Shop Drawing Submittal Review

Project Name: Webster University-**ISB**

SPEC SECTION: 22 4216.16
Commercial Sinks

RE: Sinks Product Data

PFPTB100/200/300/400 Series**Adjustable Tubular P-Traps****PFPTB101**

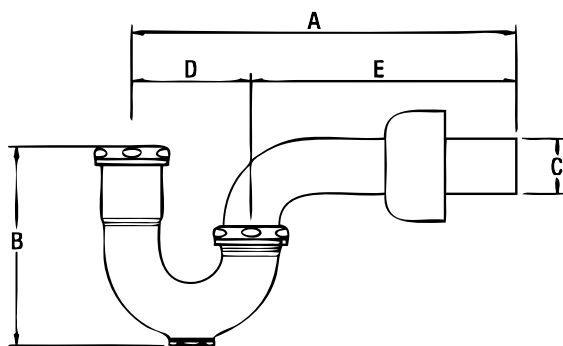
1. Provide under counter waste and supply protective piping covers as required.
Verify requirements with the architectural drawings.
2. Escutcheons are specified to be cast brass. Refer to specification section 220518.
